Item ID: D206-667-101 Accept *N900040100* Setup Start *NS1*
 Revision ID: Stop *NS2*
 Item Name: Fwd Crosstube - High 206 A/B
 Start Date: 7/29/2015 Start Qty: 1.00 *1* Cust Item ID:
 Required Date: 8/12/2015 Req'd Qty: 1.00 *1* Customer:
 Reference:

DRAWING NO. D206-667-141	TITLE CROSSTUBE ASS'Y (206B HIGH FWD)	REV. C	DART AEROSPACE LTD ENGINEERING ORDER		D.E.O. NO. D206-667-141-C-1	SHEET NO. SHEET 1 OF 1	SCALE NTS
DRAWN <i>qp</i>	CHECKED <i>ASS</i>	MFG. APPR. <i>MD</i>	APPROVED <i>MD</i>		DE APPR. <i>MD</i>		
DATE 11.07.15	DATE 11.07.20	DATE 11.07.21	DATE 11/07/21		DATE 11.07.21

PURPOSE:

REPLACE MAGNOBOND WITH PROSEAL.

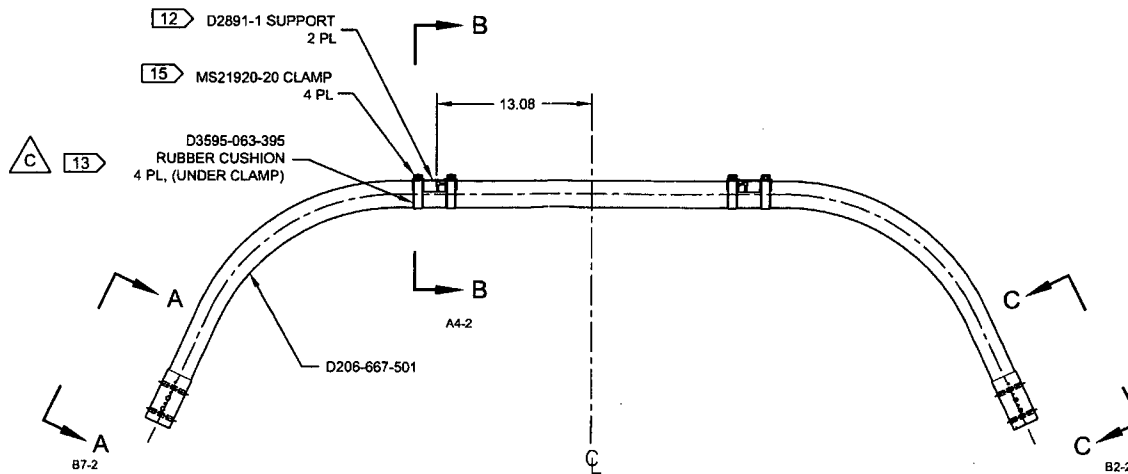
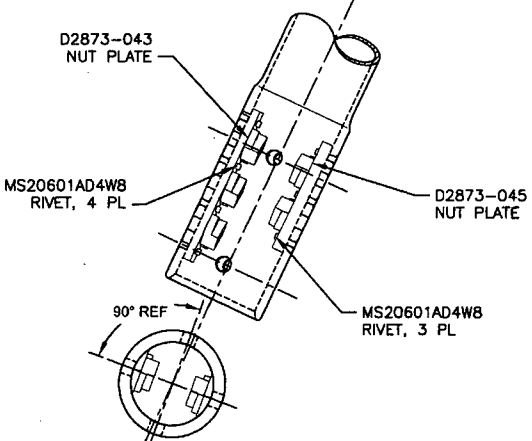
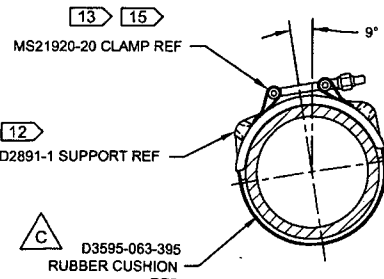
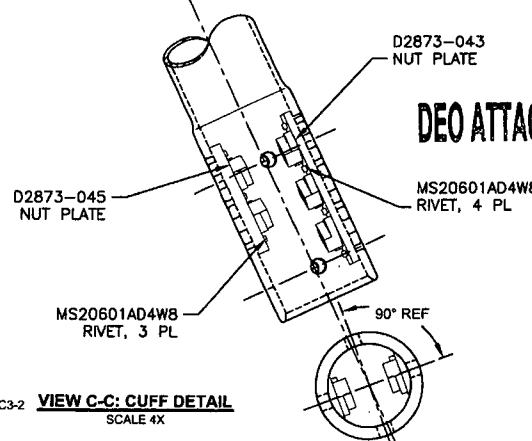
NOTE 12 & 15, SHEET 1 IS AMENDED AS FOLLOWS:

- 12) INSTALL D2891-1 SUPPORT USING 0.03" TO 0.06" THICK LAYER OF MAGNOBOND 6398 PER QSI 015. LET CURE FOR 12 HOURS AFTER INSTALLATION AND PRIOR TO PACKAGING.
- 15) TORQUE CLAMPS 80 TO 100 IN-LB. ENSURE AT LEAST 1.5 THREADS SHOWING IN SAFETY AND THAT NUT HAS NOT BOTTOMED-OUT AFTER TORQUING.

Item	Qty -141	Part Number	Description
9	A/R	PROSEAL 890 B-2	SEALANT, AMS-S-8802 CLASS B-2

- 12) TO INSTALL D2891-1 SUPPORT: ABRASE MATING SURFACE OF SUPPORT AND CROSSTUBE WITH 180-GRIT SANDPAPER AND REMOVE RESIDUE WITH MEK (OR EQUIVALENT). APPLY A 0.04" TO 0.07" THICK LAYER OF PROSEAL 890 CLASS B-2 (OR AMS-S-8802 CLASS B-2) SEALANT TO MATING SURFACE OF SUPPORT.
- 15) TORQUE CLAMPS 80 TO 100 IN-LB. ENSURE AT LEAST 1.5 THREADS SHOWING IN SAFETY AND THAT NUT HAS NOT BOTTOMED-OUT AFTER TORQUING. **PRIOR TO PACKAGING, RE-CHECK TORQUE ON CLAMPS AFTER PROSEAL 890 SEALANT HAS CURED FOR 72 HOURS.**

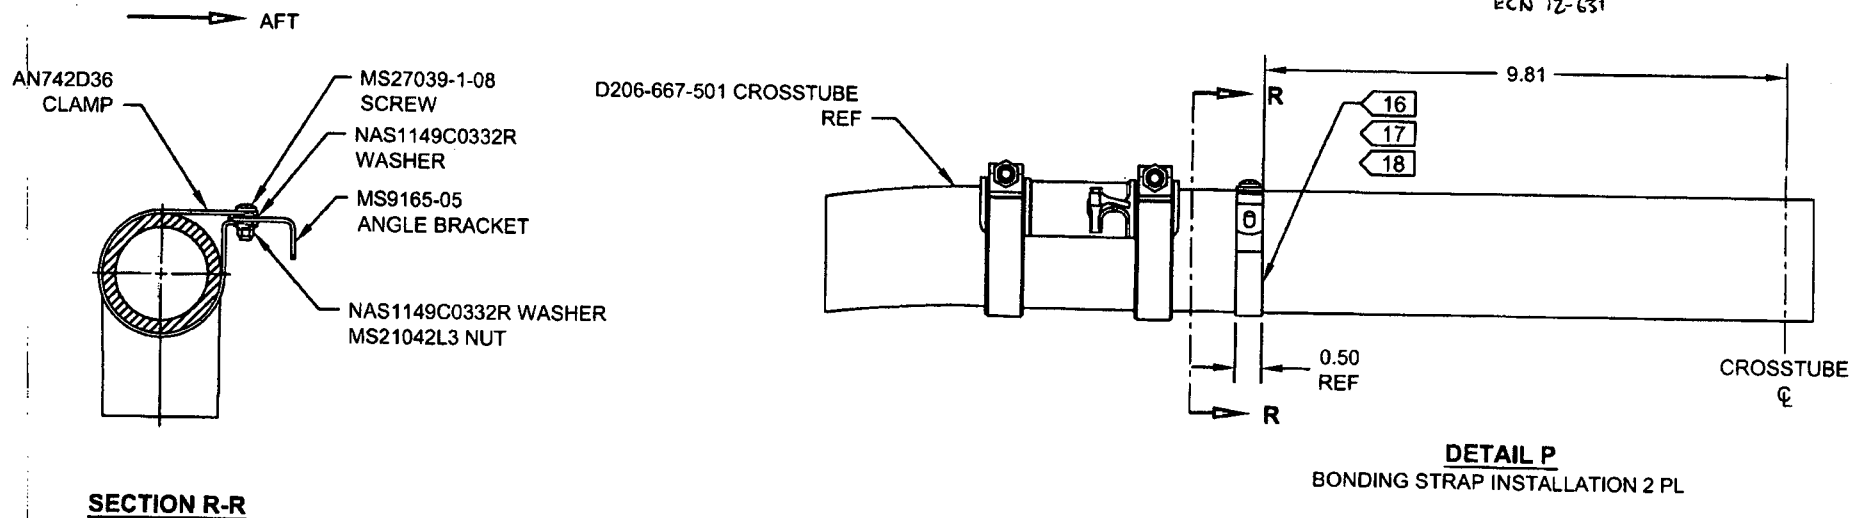
ADD ELECTRICAL GROUNDING STRAP

ITEM	QTY -141	PART NUMBER	DESCRIPTION
1	X	D206-667-141	CROSSTUBE ASSEMBLY (206B HIGH FWD)
10	2	AN742D36	CLAMP
11	2	MS9165-05	ANGLE BRACKET
12	2	MS21042L3	NUT (OR MS21042-3)
13	2	MS27039-1-08	SCREW
14	4	NAS1149C0332R	WASHER (OR AN960C10L)

- 16) MASK AREA UNDER CLAMP PRIOR TO PAINTING
 17) SEAL EDGES WHERE AN742D36 CLAMP MEETS WITH THE CROSSTUBE USING SIKAFLEX-241/-291 OR MIL-S-8802 CLASS B2 OR PROSEAL 890 SEALANT
 18) PERFORM RESISTANCE CHECK TO ENSURE MAX RESISTANCE IS 10 MILLIOHMS
